SAN ONOFRE NUCLEAR GENERATING STATION

IMPROVED TECHNICAL SPECIFICATIONS CONVERSION

ITS SECTION 3.4 REACTOR COOLANT SYSTEM (RCS)

Current Technical Specification (CTS) Markup and Discussion of Changes (DOCs)

3.4-49

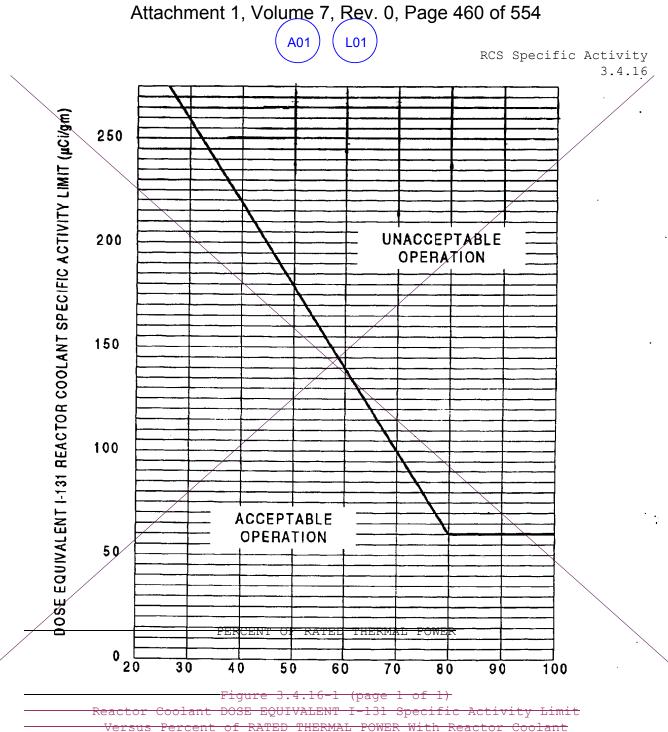
- LCO 3.4.16, "RCS Specific Activity," is revised to delete references to gross specific activity, and reference limits on DOSE EQUIVALENT I-131 and DOSE EQUIVALENT XE-133, and delete Figure 3.4.16-1, "Reactor Coolant DOSE EQUIVALENT I-131 Specific Activity Limit versus Percent of RATED THERMAL POWER."

- a. ACTION A is modified by deleting the specific value for the DOSE EQUIVALENT I-131 limit from the Condition and replacing it with an upper limit requirement (i.e., not within limit), deleting the reference to Figure 3.4.16-1, and modifying the reference to LCO 3.0.4 in the Required Actions Note.

3.4-49

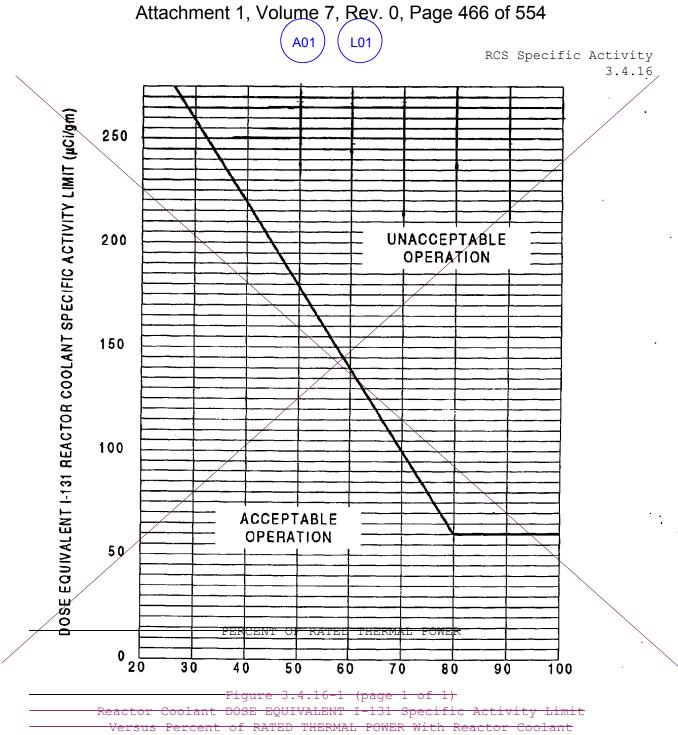
- LCO 3.4.16, "RCS Specific Activity," is revised to delete references to gross specific activity, and reference limits on DOSE EQUIVALENT I-131 and DOSE EQUIVALENT XE-133, and delete Figure 3.4.16-1, "Reactor Coolant DOSE EQUIVALENT I-131 Specific Activity Limit versus Percent of RATED THERMAL POWER."

- a. ACTION A is modified by deleting the specific value for the DOSE EQUIVALENT I-131 limit from the Condition and replacing it with an upper limit requirement (i.e., not within limit), deleting the reference to Figure 3.4.16-1, and modifying the reference to LCO 3.0.4 in the Required Actions Note.
